# REGIONAL REVIEW FINDING

ARC REVIEW CODE: R508101

**Submitting Local Government:** City of Atlanta  
**Name of Proposal:** 1033 Jefferson Street

Preliminary Report:	August 10, 2005	<b>DEVELOPMENT OF REGIONAL IMPACT REVIEW REPORT</b>	Project:	1033 Jefferson Street #783
Final Report Due:	September 7, 2005		Comments Due By:	August 22, 2005

SHEET TITLE  
PROPOSED SITE PLAN  
SCALE: (UN)G.O.J.  
DRAWN BY

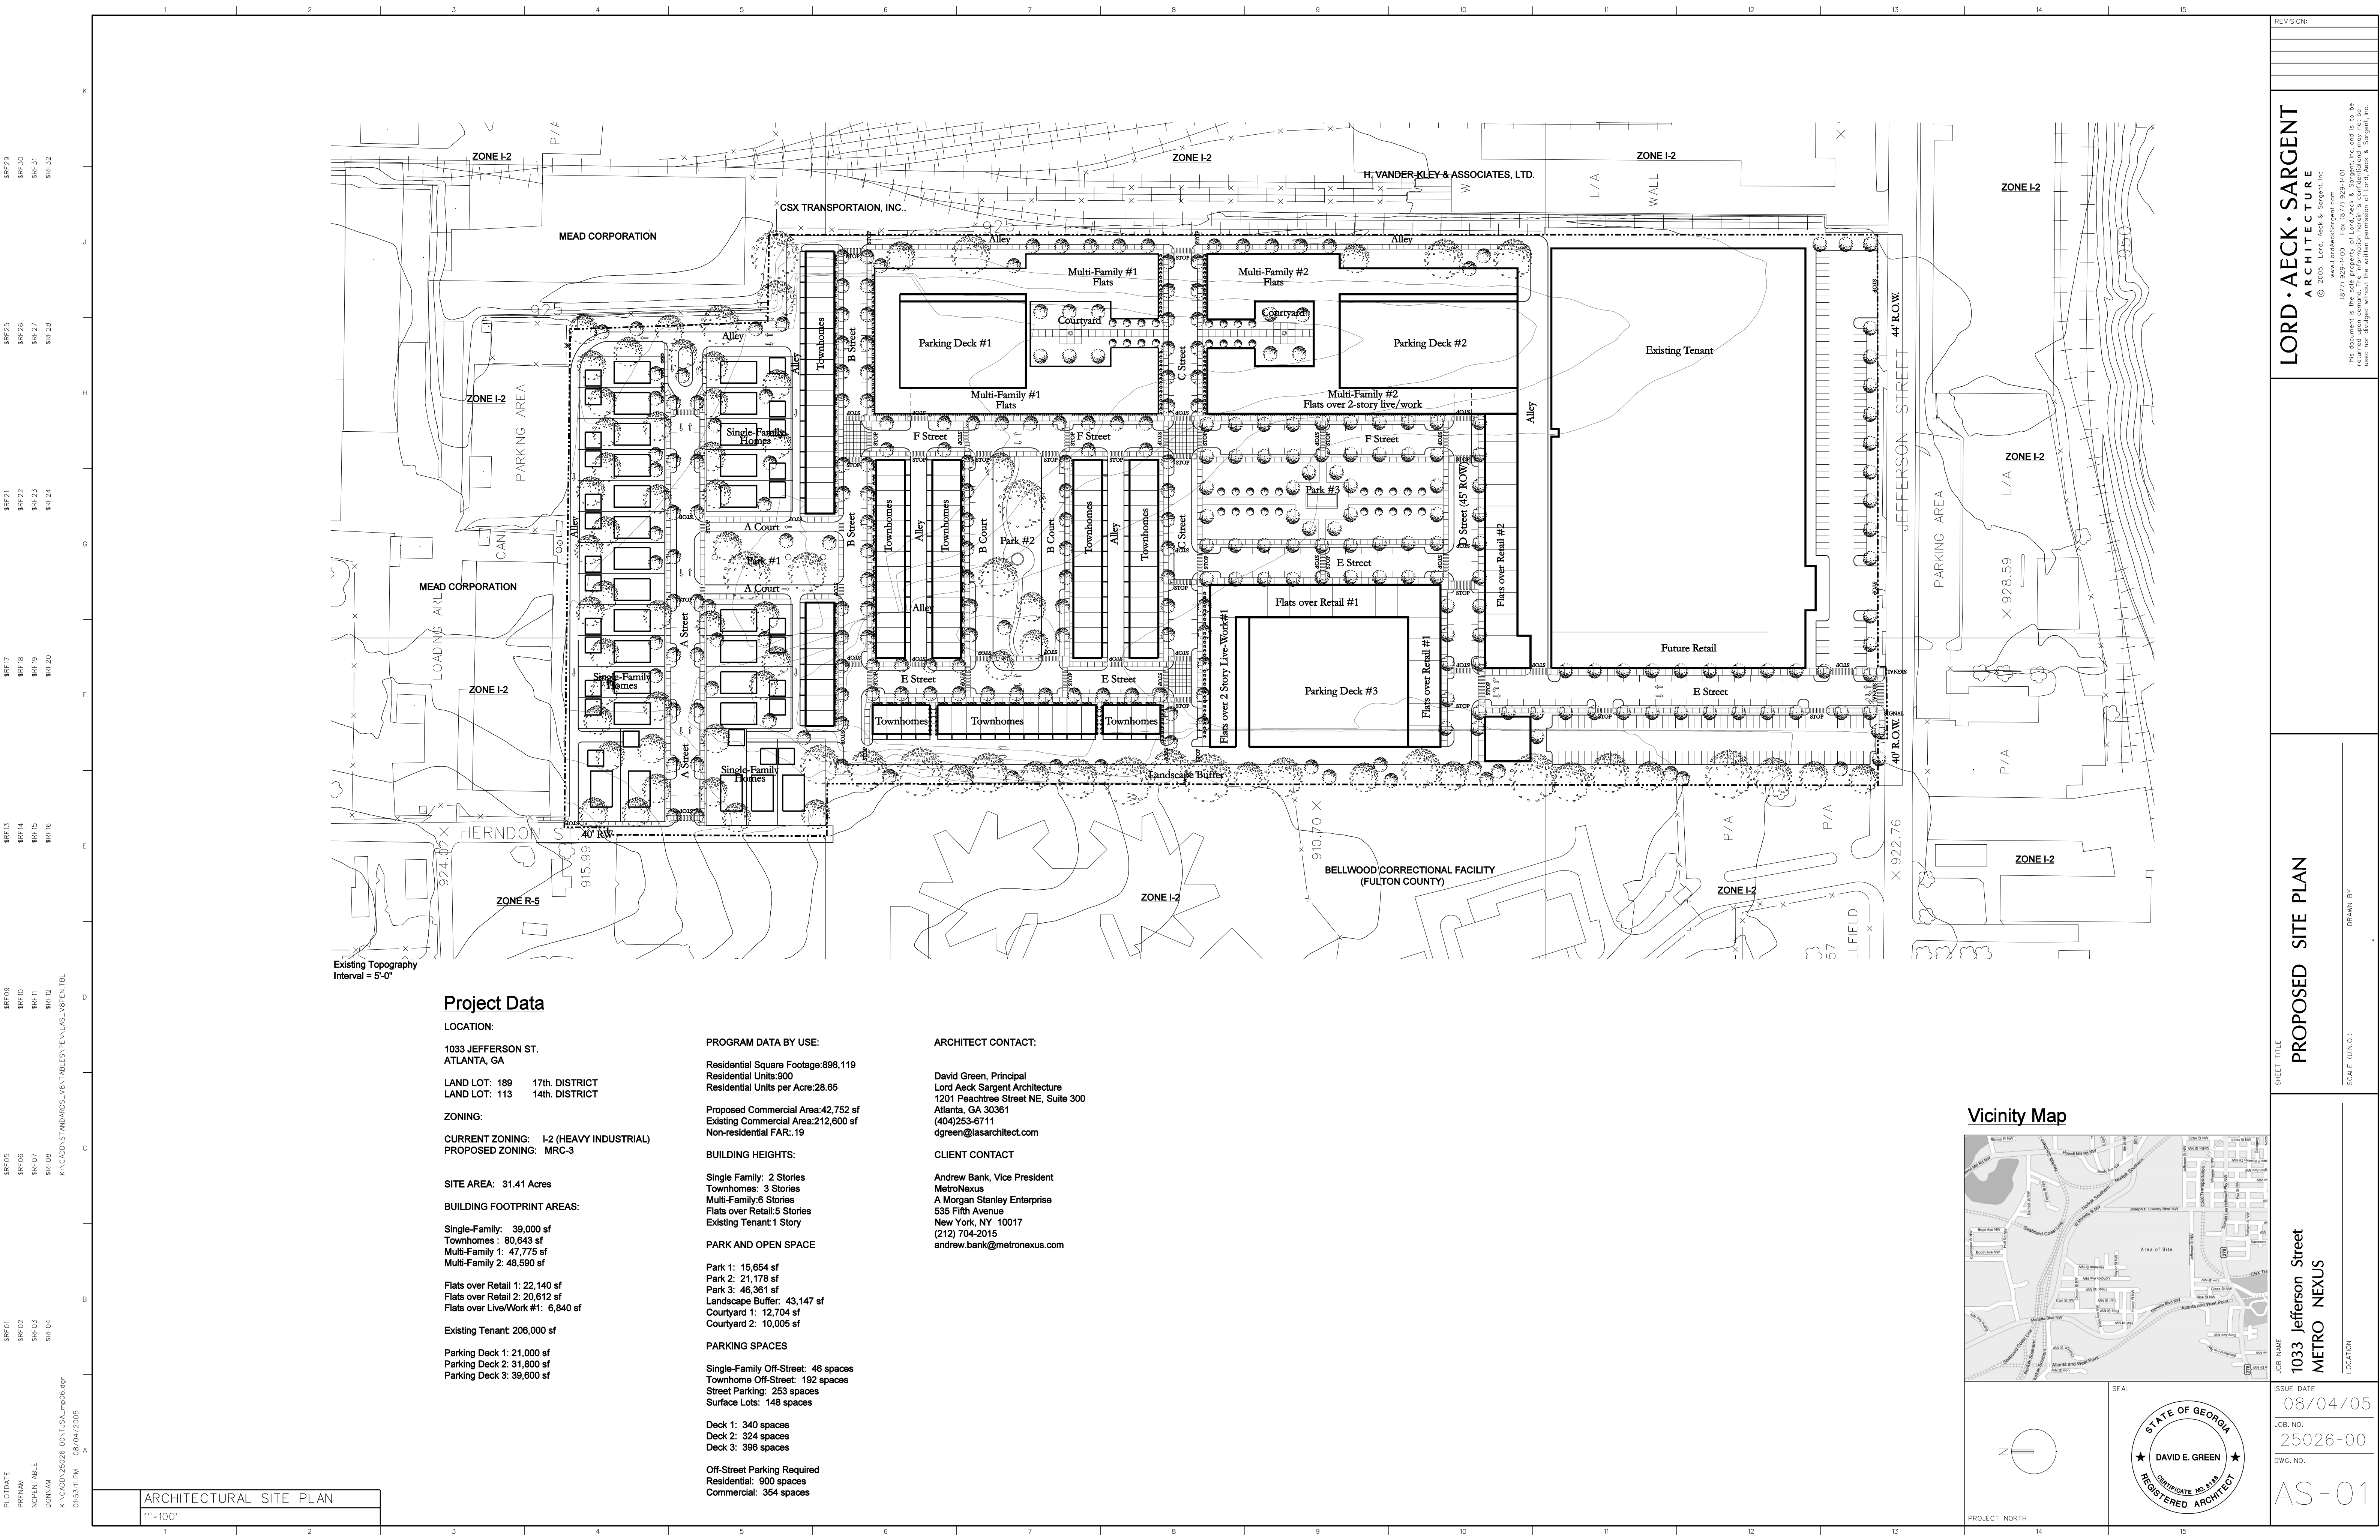
It is important to note that the proposed development is located along the proposed Beltline, for both the transit and the pathway/greenway. The proposed development should consider the proposed alignments of the Beltline, as the site plan is refined. A policy based connection is recommended at this time. At such time that the Beltline is implemented and constructed, convenient and safe access to the Beltline should be provided.

The proposed development incorporates many several design principles that will help to create a true pedestrian oriented mixed use development. The proposed development incorporates alleys for rear parking to the townhomes, sidewalks on both sides of the street, parking decks with street front retail and commercial uses, and three separate community greenspace areas. The single family homes are proposed on small lots with parking garages located in the back of the property. Finally the proposed plan is connecting streets and alleys to the existing street system, providing multiple access points to the existing neighborhood and new commercial uses.
